Site Analysis, Context, & Concept Southwest References

SECTION 2

DESIGN PROCESS

Design Process Internal Pick Up & Drop Off

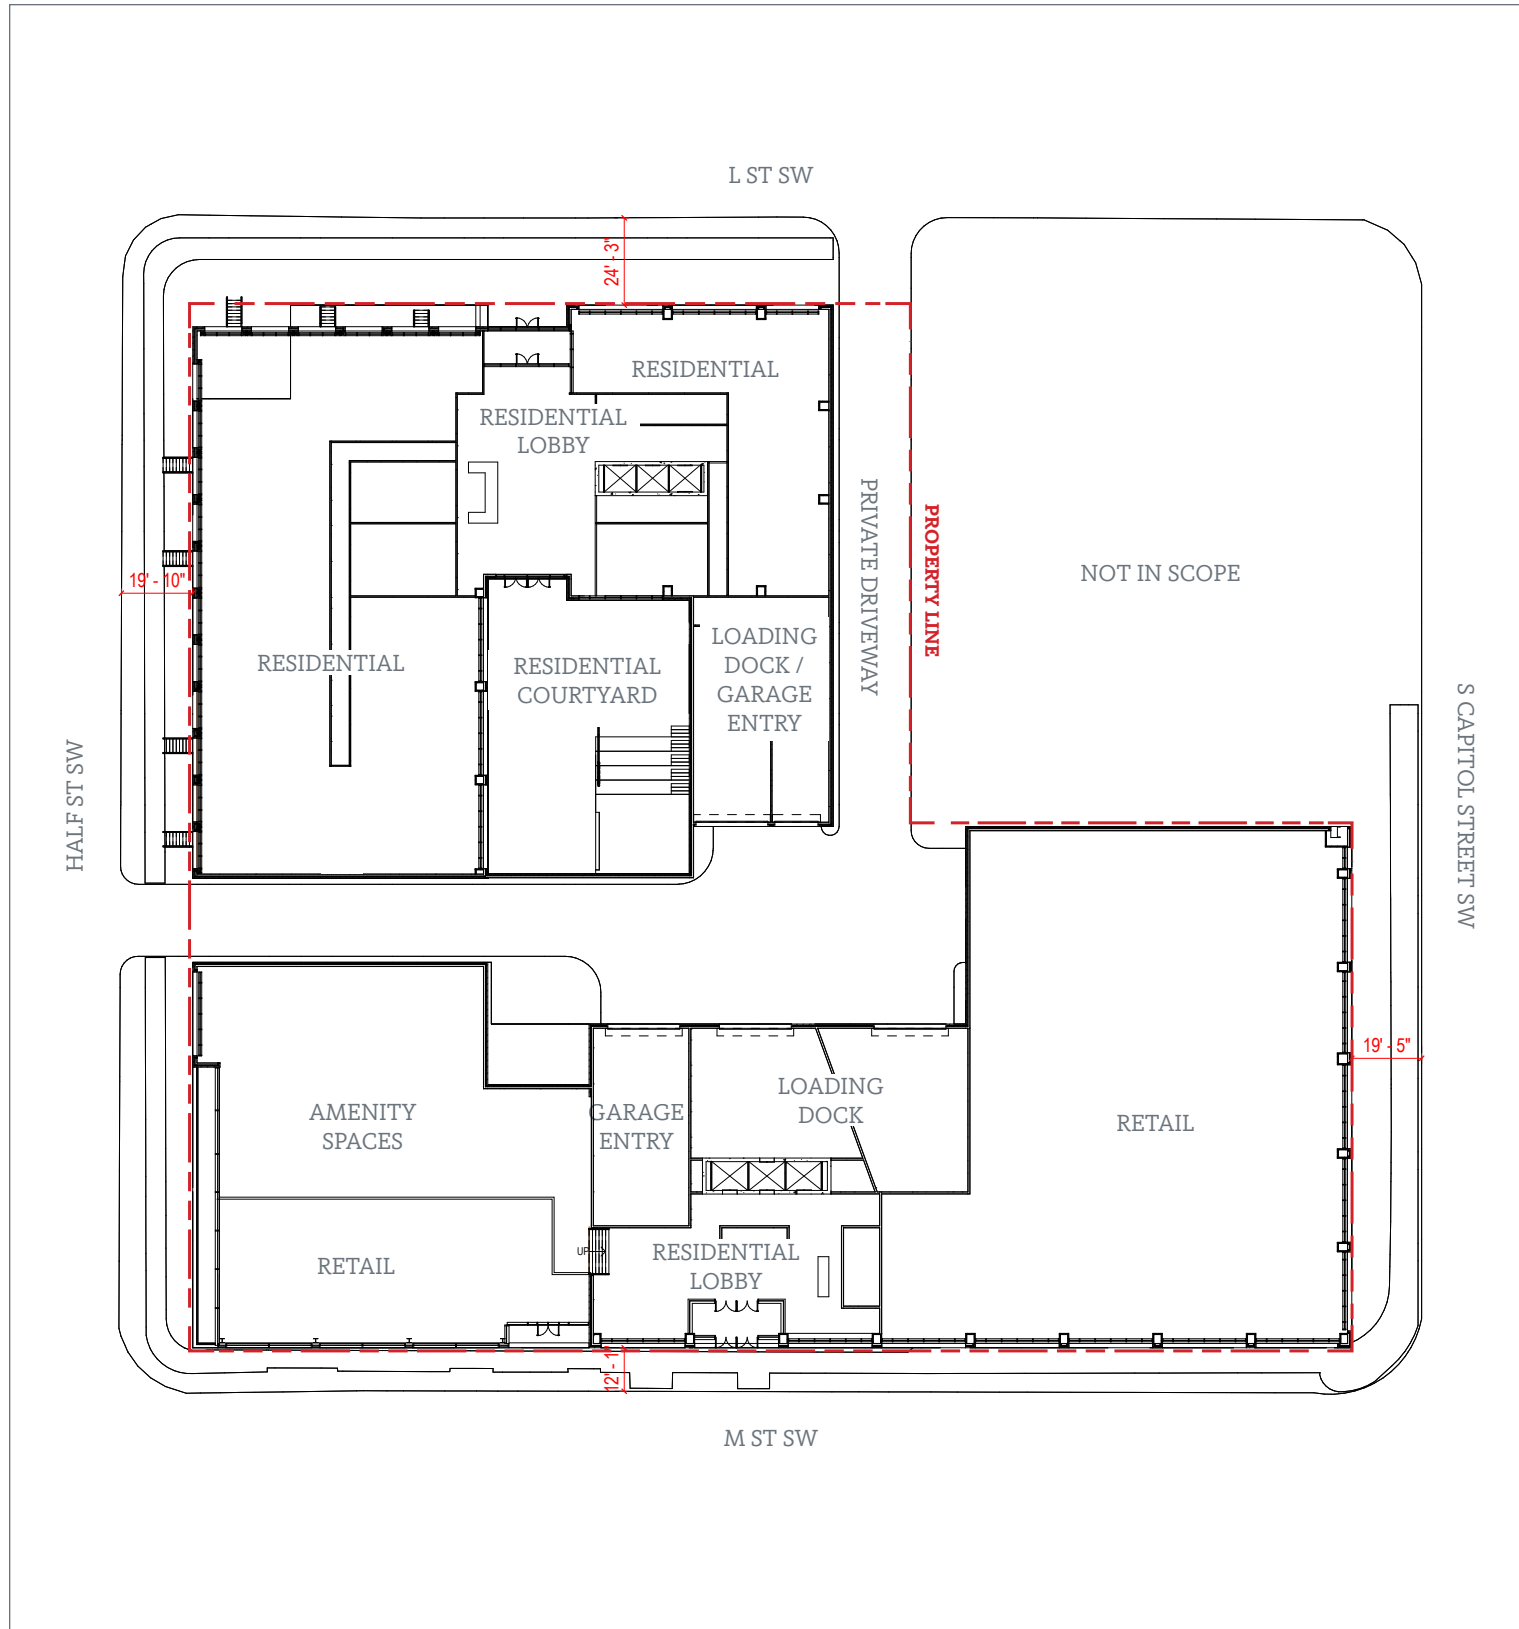
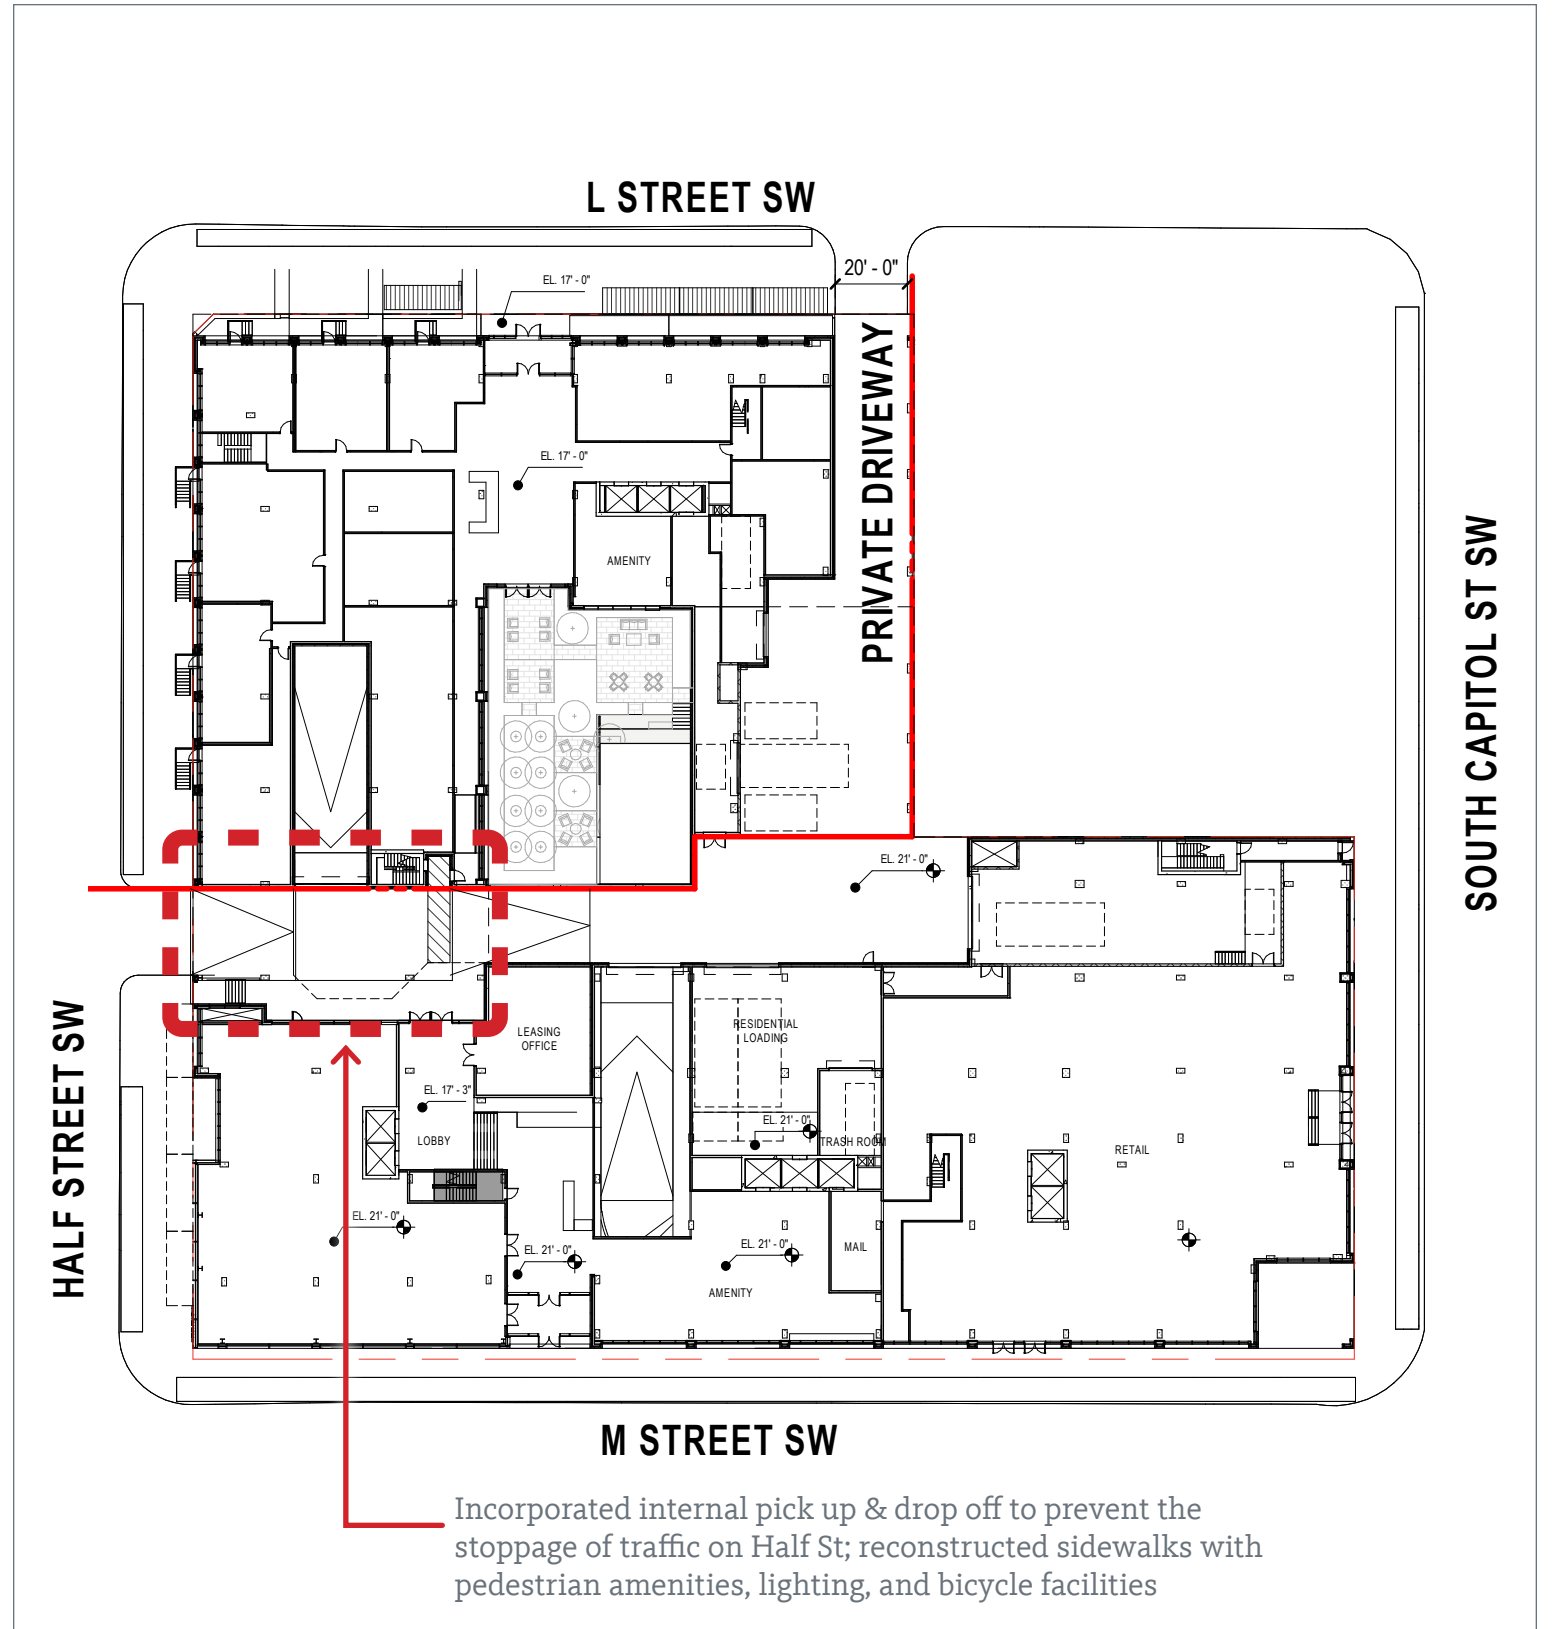
Pre-ANC Feedback

Current

Revised 'Hyphen' Facade

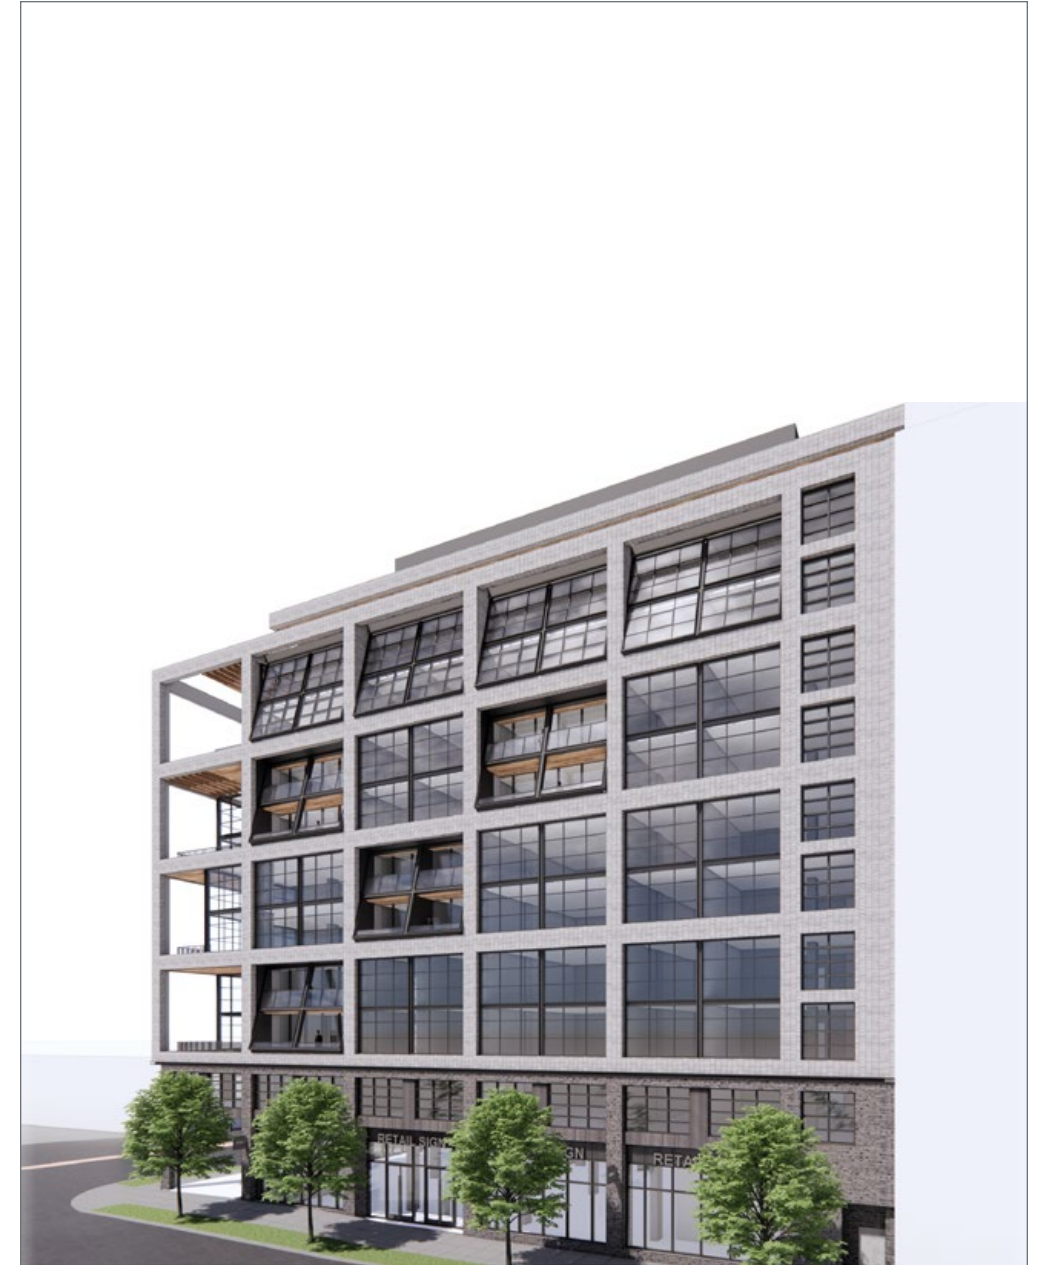
- Added balconies.
- Updated brick detailing to reflect the mid-century detailing prevalent in Southwest.
- Introduced additional reveals in the massing.
- Enlarged window openings / increased glass.

- Removed the 'hyphen' facade to consolidate the design vocabulary.
- Added more rotated windows and balconies.
- Updated the rotation of the rotated balconies to be consistent and not rotate out at the top of the opening (now inwardly-rotate).
- Converted precast concrete grid to brick.
